This Service Information Bulletin (Revision 2) replaces SI B11 06 21 **dated April 2022**.

### What's New (Specific text highlighted):

- Information updated about engine oil filter cap drain plug

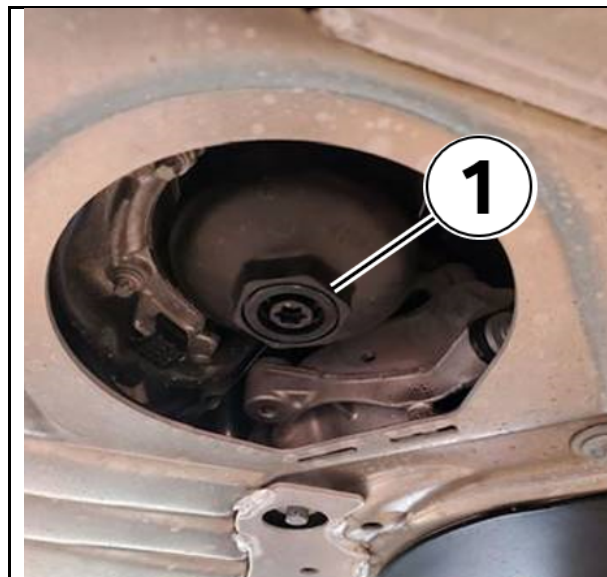
The vehicle may or may not have an engine oil filter cap with a plastic drain plug located in the center (1).

Do not remove the engine oil filter drain plug until further notice.

Set oil filter element P/N 11 42 7 583 220 and P/N 11 42 7 848 321 do not have the O-ring for this drain plug included in the contents.

Remove the entire engine oil filter cap to drain the engine oil and remove the engine oil filter.
